RE: Docket Number EERE-2019-BT-STD-0018: Energy Conservation Standards for Distribution Transformers

This letter constitutes the comments of the Appliance Standards Awareness Project (ASAP), American Council for an Energy-Efficient Economy (ACEEE), and the Natural Resources Defense Council (NRDC) on the preliminary technical support document (PTSD) for distribution transformer standards. 86 Fed. Reg. 48058 (August 27, 2021). We appreciate the opportunity to provide input to the Department.

Figure 1: Transformer efficiency (left) and total loss (right) curves for designs optimized at 50% (blue) and 30% (red) load factor.

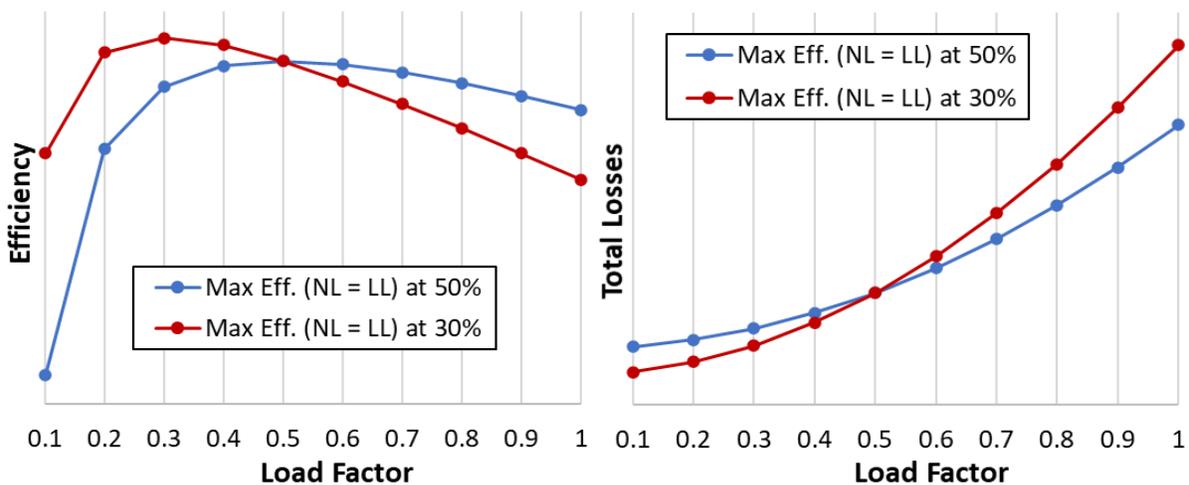
for RU2 are negative;⁶ this is because designs that minimize load losses are selected even though they do not deliver first-year energy savings relative to EL0. This example highlights how the test procedure is not providing an accurate relative ranking of transformers. To illustrate this more clearly, Figure 1 plots efficiency and total loss curves for two transformers with equal efficiencies and losses at 50%; i.e., these two transformers could represent minimally DOE compliant transformers. The blue curve, prioritizing load losses (LL), reaches maximum efficiency at 50% while the red curve, prioritizing no-load losses (NL), reaches maximum efficiency at 30%. If these transformers were operating at a PUL consistent with DOE’s own analysis (30%) the red curve transformer prioritizing core losses would have 22% less total losses.⁷ For comparison, DOE’s projected first-year average energy savings for EL4 in the preliminary analysis are 19-42% for LTs, as shown in Table 7.2.2.⁸ Thus, these two transformers, while both representing minimally compliant designs at the 50% test PUL, would have much different relative efficiency rankings if evaluated at 30% PUL. The blue curve design has over-emphasized the winding loss minimization at the expense of minimizing core losses in a way that negatively impacts its energy efficiency at lower, more realistic loads. For simplicity, our analysis herein assumes that load factor equals PUL (i.e., peak load equals transformer nameplate rating).⁹ The only two assumptions used to plot Figure 1 are well known relationships to estimate transformer loss curves.¹⁰ Step-by-step details for the savings estimate calculations can be found in the Appendix on p. 10 of these comments. These savings calculations mirror those published previously by EPA.¹¹

⁷Maximum efficiency occurs where load losses equal no-load losses. If both curves have total losses of 100 W at 50%, the load and no-load losses of the blue curve will each be 50 W at 50% load, and those of the red curve will be 26.5 W each at 30% load. (The load and no-load losses of the red curve at 50% load will be 73.5 W and 26.5 W, respectively.) The load and no-load losses of the blue curve will be 18 W and 50 W, respectively, at 30%. Thus, total losses at 30% will be 68 W for the blue curve and 53 W for the red curve, for savings of $(68 - 53) \text{ W} / 68 \text{ W} = 22\%$

The derivation outlined below is intended to clarify how the energy savings discussed on pp. 2-3 are calculated. This approach mirrors that used in a 2017 EPA publication.³⁴ The same energy savings may be obtained from the efficiency curves plotted in Figure 1.

3. Shown in Figure 1, losses of the DOE and TOC designs are equal at 50% load (same efficiency)

We urge DOE to revise transformer efficiency ratings so that they provide a more accurate relative ranking of transformers. We recognize that DOE recently published a test procedure final rule in which the Department decided to leave the rating point (50% PUL) for LT transformers unchanged.⁴ We urge DOE to reconsider that decision based on the data DOE itself has provided in the PTSD. DOE's analysis confirms that real-world LT average annual PULs are significantly lower than that prescribed in the test procedure. Table 2.8.1 of the PTSD shows estimated average annual PULs ranging from 27 to 32% for LT representative units (RUs); these PULs are lower than the Department's 2013 estimates of 34-44%. Thus, DOE estimates that current loads are lower than those assumed in the 2013 rulemaking analysis,⁵ even as electricity use has grown by 1.1% per year over that same period according to the EIA's Annual Energy Outlook (AEO). DOE cites future electrification driven PUL growth as one justification for leaving the test procedure PUL at 50%. However, it would take 57 years to reach 50% PUL using an initial average PUL of 30% and a PUL growth rate of 0.9% per year as assumed in the PTSD.

Figure 2: DOE RMS Load (PUL) data for RU2 (left) and total losses for the two transformers (right).

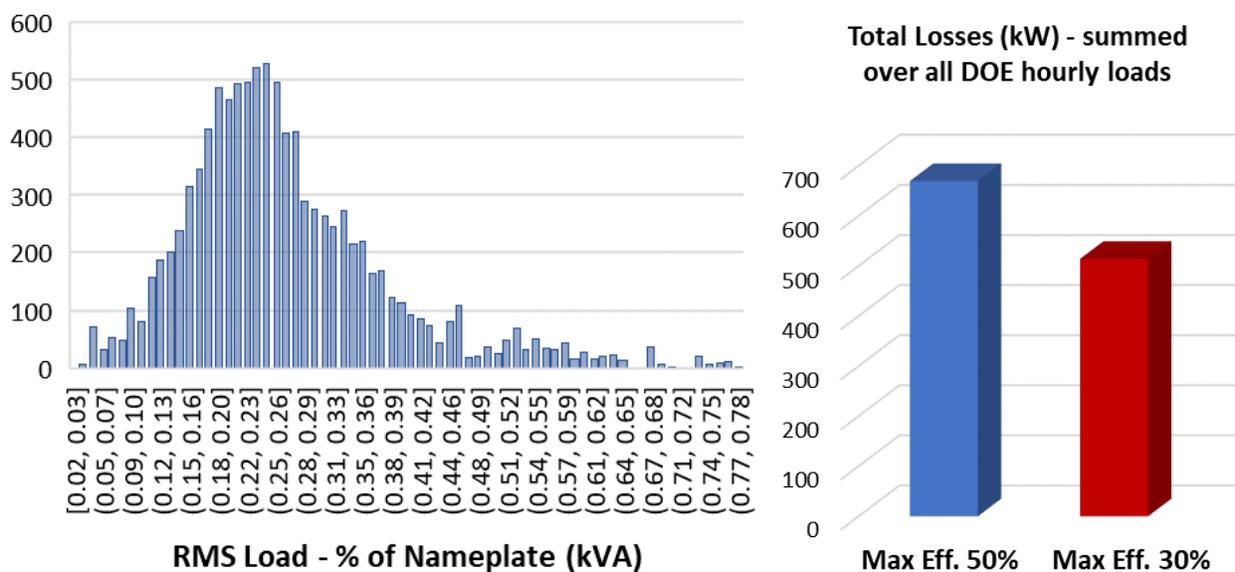
DOE discusses in the recent test procedure final rule that the risk of selecting too low a standard PUL is greater than that of selecting one too high.¹² While it is true that total losses and thus effects of efficiency will be higher at high PULs, significant savings are available for designs optimized at 30% PUL versus the 50% PUL test point even across a broad distribution of real-world PULs. For example, the left portion of Figure 2 plots average RMS loads (PUL) for RU2 from DOE’s hourly loading model results; this data was obtained from the “Results-Consumer” sheet in the RU2 summary spreadsheets accompanying the PTSD.¹³ Next, we calculated the total losses across these real transformer load points for both the 50% PUL optimized design (blue) and the 30% PUL optimized design (red), as shown on the right side of Figure 2; we set both transformer curve losses to 100 W at 50% PUL, then summed the total losses across all the transformer PULs shown on the left side of Figure 2. Overall, the transformer optimized for 30% PUL has 23% less total losses than the transformer optimized at 50% PUL. We note that only 5% of loads in Figure 2 are above 50% PUL. These results provide strong evidence that energy savings obtained at lower real-world PULs will more than offset any increased losses at PULs above 50%.

utilize both amorphous metal (AM) and grain-oriented electrical steel (GOES) cores. Thus, DOE's own engineering analysis suggests that real-world energy savings of 23%, from Figure 2, are possible with a cost increase of only 4% for RU2 with current ELO designs. Based on design-specific reported load losses at both 50% and 100% found in the spreadsheet, the load loss characteristics of the designs examined herein are very similar to the red and blue curves shown in Figure 1; however, we encourage DOE to use available bid data to better understand the typical loss characteristics of purchased transformers.

To put these energy savings and cost increases in perspective, 23% savings would be equivalent to an efficiency between EL2 and EL3 for RU2 based on Table 7.2.2. However, the 12 lowest-cost designs at these ELs for RU2 have average manufacturer selling price estimates of \$1283 and \$1347; these initial costs represent increases of 7% and 12%, respectively, over the 12 lowest-cost ELO designs. We obtained similar results using DOE's PUL data and engineering designs for RU4 and RU5, where energy savings of 24% and 18%, respectively, are possible with cost increases of 11% and 7%, respectively for ELO designs. Energy savings of 18% for RU5 is equivalent to EL3, wherein the 12 lowest-cost designs cost 27% more than the 12 lowest-cost ELO designs. Together, RU2, RU4, and RU5 combined represent about 90% of estimated shipped capacity.¹⁶ These results suggest that significant savings would be available at a lower initial cost if the test procedure PUL was changed to 30%. In other words, ***these results indicate that the disconnect between the test procedure PUL and real-world PULs may be resulting in overestimates of the incremental cost to reach a certain level of energy savings.*** We therefore urge DOE to change the test procedure PUL from 50% to 30% for LTs.

Figure 3: Comparison of LT transformer efficiency in the US, India, China, and the EU.

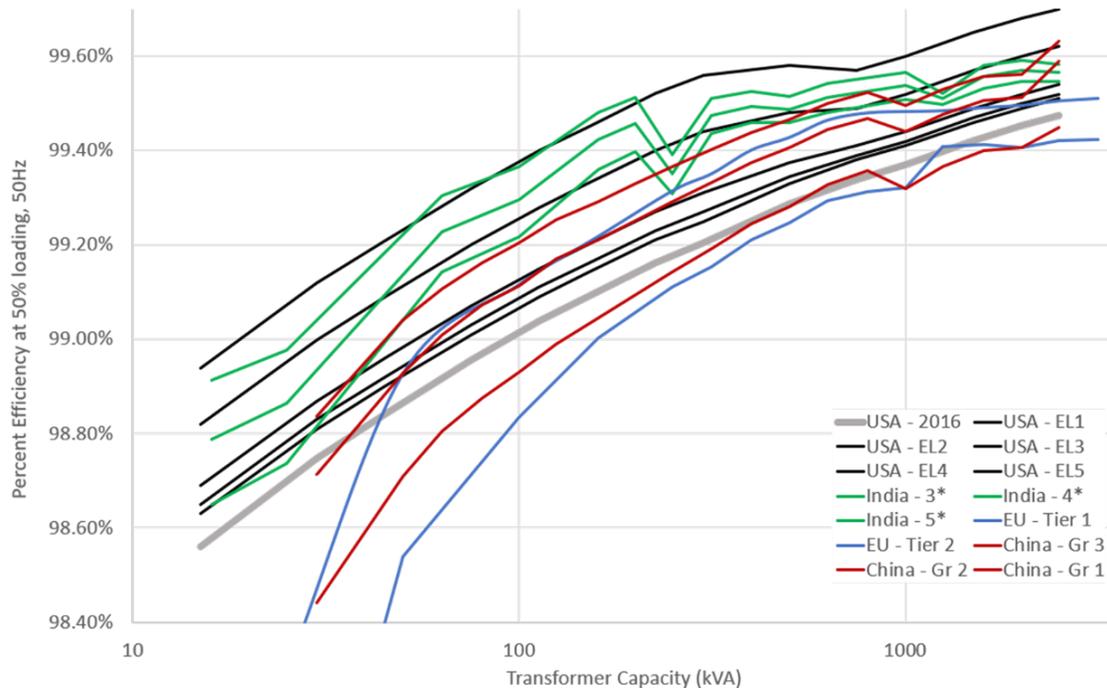
DOE should aim to establish world-leading transformer energy efficiency levels. In the years since DOE last revised its standards, major economies around the world including India, China, and the EU have set new transformer efficiency thresholds. Many of these levels far exceed the current DOE standard levels and some are beyond even the intermediate ELs evaluated in the PTSD. For example, current efficiency thresholds for three-phase LTs, represented by RU4 and RU5, are shown in Figure 3;²⁹ the efficiency curves are adjusted to the common IEC definition of kVA and 50Hz performance. The five ELs defined in the PTSD are shown in black,³⁰ where the proposed EL1, EL2, and EL3 are exceeded by recent efficiency thresholds established in India, China, and Europe. Based on this initial comparison, we encourage DOE to evaluate international standards in greater detail to ensure that cost-effective technology solutions from international markets are fully considered in the revision of future US standards.
